# Errata

## SLG4653x

### CE-GP-002

*This document contains the known errata for SLG46533, SLG46534, SLG46535, SLG46536, SLG46537, SLG46538 and the recommended workarounds.*

Figure 1

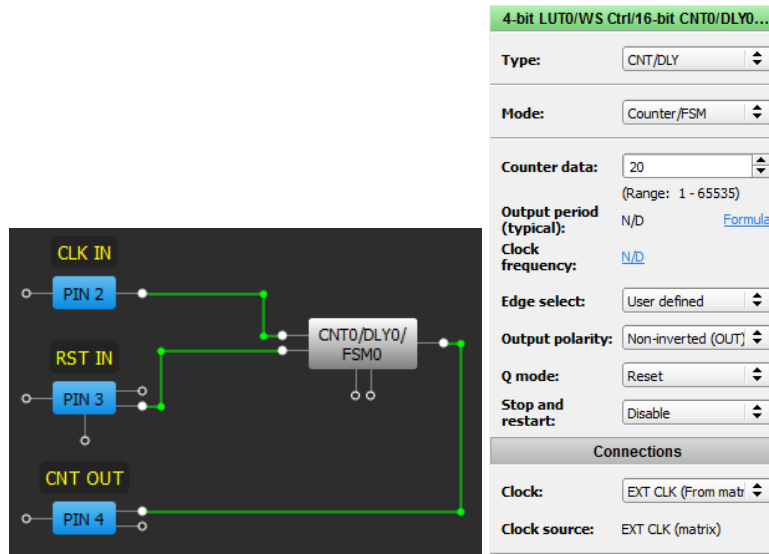
If the Counter Reset is asserted at the same time as a rising clock edge, it is possible that the Counter Data will be reset incorrectly and the counter output may appear faster than expected. This phenomenon appears more often as the clock frequency increases.

Figure 4

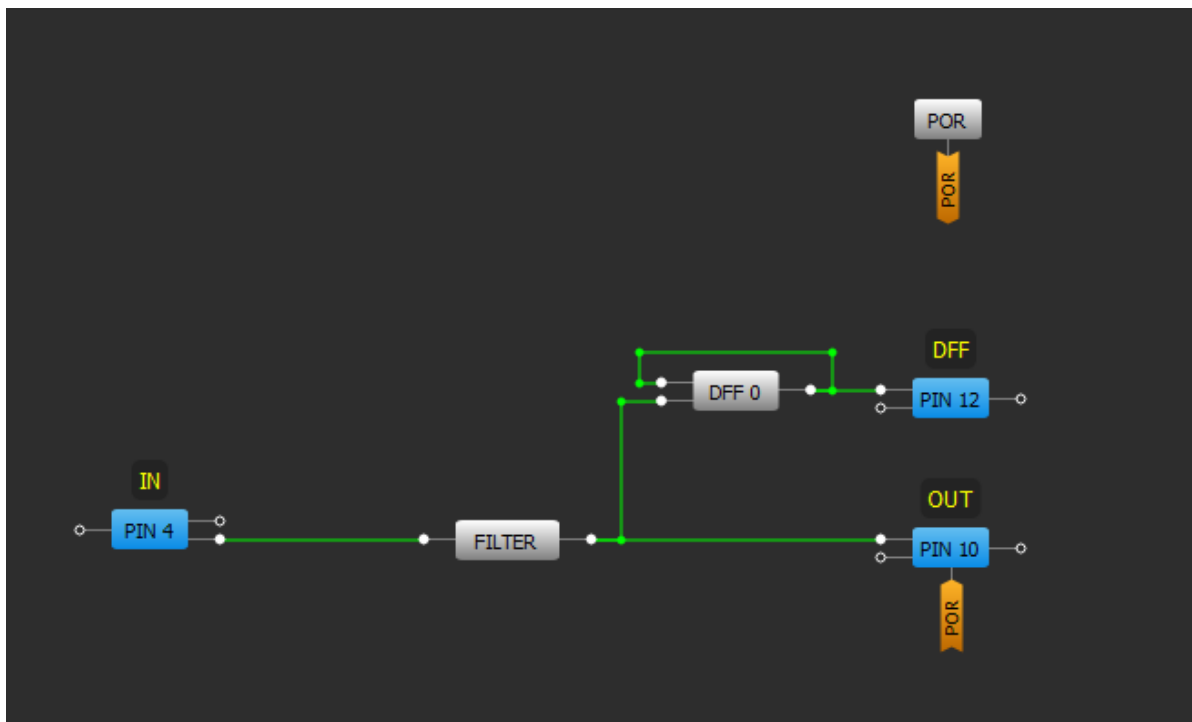
If clock type high frequency input comes in, the FILTER cell may not filter out it. There are several factors like input frequency, duty cycle and LOW duration in such signal that may lead to its passing through FILTER block.

Currently there is no workaround for this issue. Filter block is good at filtering short spontaneous glitches. It is intended to be used in series connection before the delay cell to avoid its latching.

Figure 8

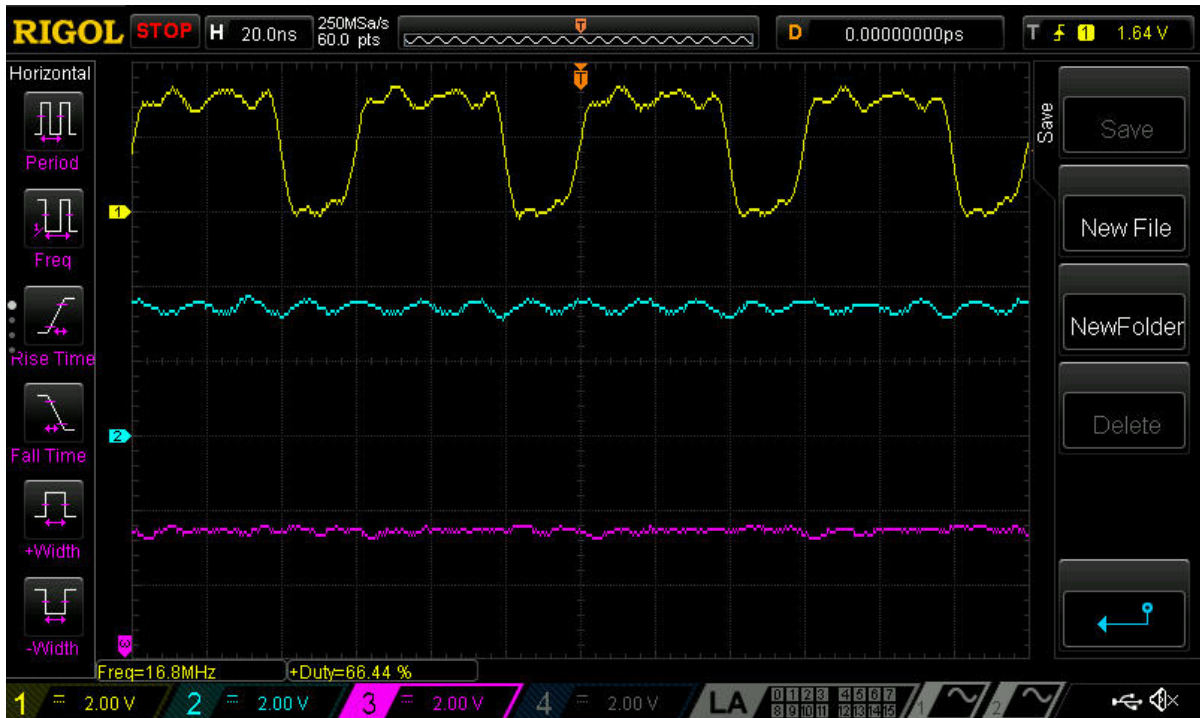
4. Period is 60ns. Pulse width is 40ns DC=66.67% (Correct functionality)

Figure 9

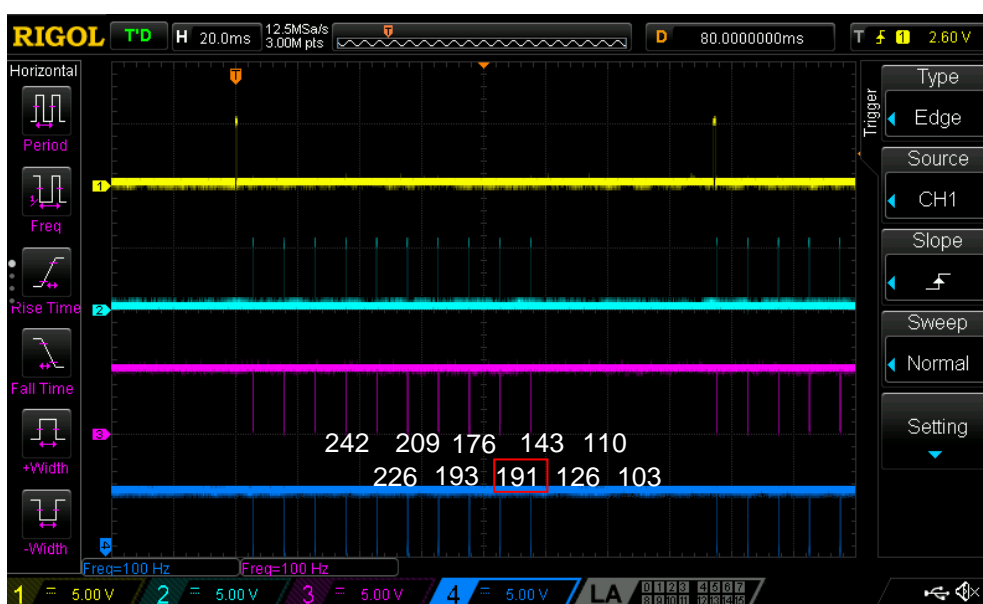
Asynchronous interaction between the CNT/DLY clock input and the I2C latch signal (generated by an I2C read command of the CNT/DLY block's count value) can result in an incorrect I2C data read. The CNT/DLY block will count accurately, but the count value transferred into the block's I2C read register might be loaded incompletely if the I2C latch signal and the clock input occur at about the same time.

The example data capture below shows ten periodic I2C reads of CNT2/DLY2 configured to count down at about 16 clocks per read. The sixth read sample erroneously shows a value greater than that of the fifth. The seventh sample reads as if the previous I2C error never occurred - the difference from the fifth sample (176) to the seventh (143) is 33 clocks or 16 clocks + 17 clocks as expected.

If the possibility of incorrect I2C data reads can't be accommodated for by external software checks, one can guarantee proper operation by stopping the CNT/DLY block's clock during I2C reads through one of the following methods: by disabling the oscillator block, by reconfiguring the CNT/DLY block's clock source, or by gating an external clock using a LUT (Look-up Table) in the signal matrix. After disabling the CNT/DLY block's clock, the count registers can be read without error. Please note that this workaround will add the I2C read and processing time to the counter's overall clock period.

Figure 10: I2C Write of 16-Bit Counter Data Example

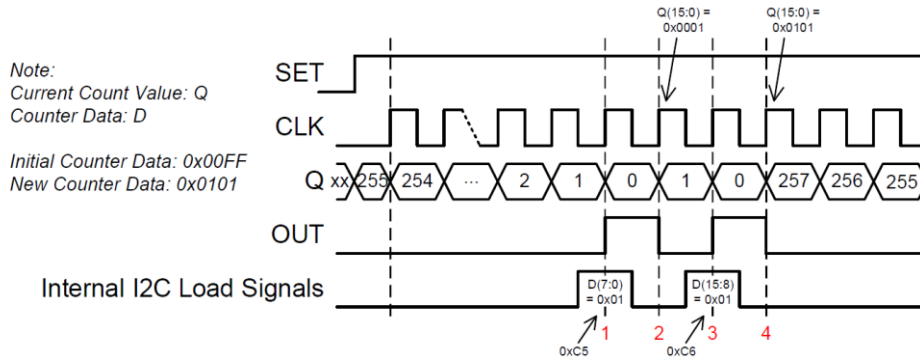
The timing diagram in Figure 10 sets up a case where an improper output will be seen on the counter. In this example, the initial Counter Data value (D) is set up as 0x00FF. As you can see, the Current Count Value (Q) decrements from 255 down to 0 with rising edges on CLK. At time “1” denoted by a red number 1, an I2C command (not shown) has just been sent to the GreenPAK device to reconfigure the Counter Data value to 0x0101.

As previously mentioned, the 16-bit value is loaded from the I2C buffers to the Counter Data registers in 8-bit chunks. Right at time “1”, the LSB byte (0x01) is loaded into the Counter Data registers. This makes the Counter Data value temporarily equal to 0x0001. At time “2” between the internal I2C load signals, the counter receives a rising edge on its clock input. This causes the Current Count Value to underflow and to be loaded with the Counter Data value which is 0x0001. At time “3”, the MSB byte (0x01) is loaded into the Counter Data registers setting the Counter Data value to 0x0101. At time “4”, the Current Count Value underflows again and is set to the Counter Data value of 0x0101.

Figure 11: 16-Bit I2C Counter Block Diagram

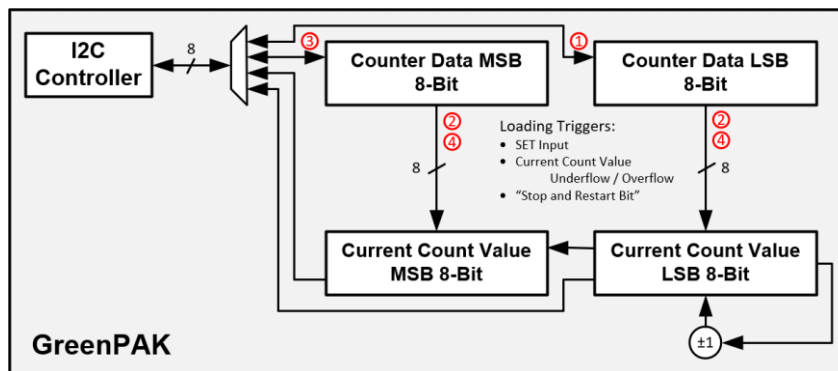
This behavior results in two output pulses on OUT when only one pulse is expected. Observing this behavior depends upon the asynchronous timing between the counter’s clock and the I2C write command to the Counter Data registers. For some applications, the extra pulse on OUT can be ignored and the counter will self-correct after underflowing, overflowing, or being SET/RESET through the GreenPAK connection matrix.

**Figure 12: Counter Behavior**

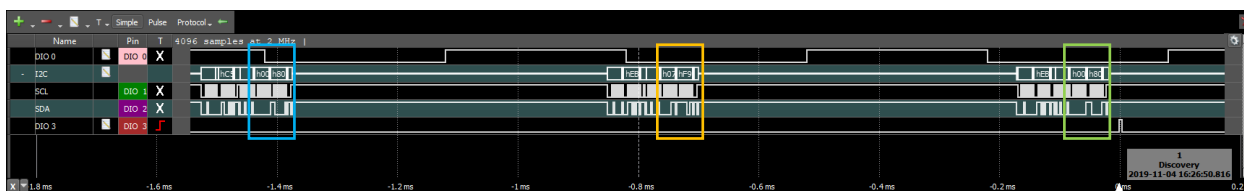
For the following condition, the Counter Data register contents are unexpectedly loaded into the counter's DFF chain. This behavior occurs when there is a falling edge on the counter block's clock input during the data return portion of an I2C read of the Counter Data registers. [Figure 10](#) shows this falling edge boxed in light blue followed by two I2C reads of the Current Count Value registers.

As you can see by the MCU data log below, the Current Count Value gradually increases from 0xF904 to 0xF907 but is unexpectedly reset to 0x8000. Please note that the colored HEX values in the MCU Log correspond to the boxed I2C read commands shown in the waveform above. As previously described, this reset occurs because there is a falling edge on the counter's clock input while the GreenPAK device is responding to an I2C read request to 0xC5 and 0xC6. (Note that 0xC5/0xC6 are the Counter Data registers and 0xEB/0xEC are the Current Count Value registers for CNT0.)

For applications where the application processor needs to read the Current Count Value while the counter is clocking, disable the "Stop and Restart Bit." When this bit is disabled, the counter's clock won't be gated internally which avoids the loss of count values during Tstop. In order to guarantee the current count value after an I2C write to the Counter Data registers, the clock should be manually stopped for the I2C write or a SET/RESET command should be generated after the I2C write. (Case 1)

Figure 11

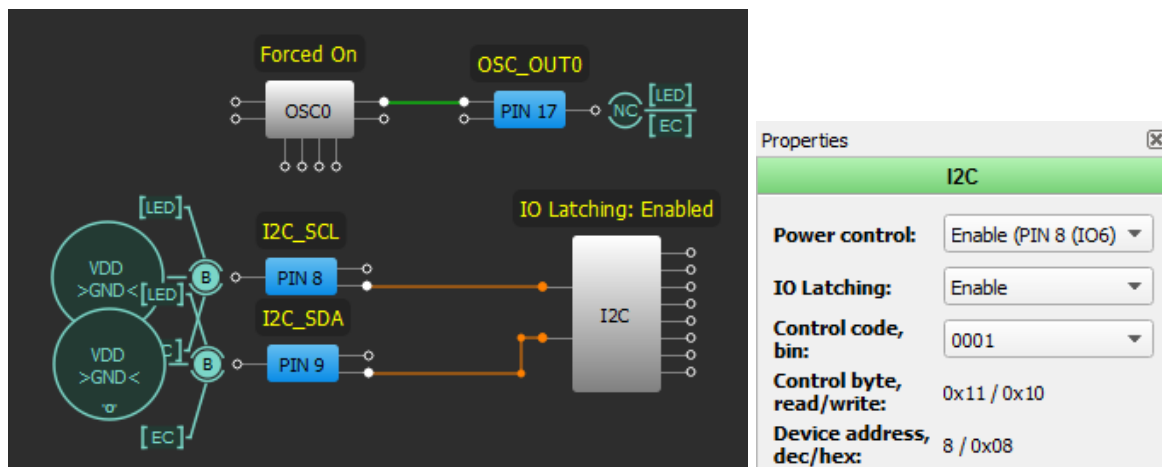
In the example below, we will be monitoring the OSC output, which is measured by a scope on Channel 3 via PIN17 (“OSC\_OUT0”). The I2C bus will be forced low to create a START bit.

By toggling I2C\_SDA low and then I2C\_SCL low, the GreenPAK registers this as a start bit and latches all General Purpose Outputs such as PIN#17(“OSC\_OUT0”). In the Figure 12, notice that PIN#17 (OSC\_OUT0) stops toggling.

Disable IO Latching in programmed OTP. This register is I2C-write locked during normal operation and therefore should be disabled in configuration file.  
Do not share I2C bus with other devices and make sure the I2C bus is not powered down while the GreenPAK is still powered through VDD.
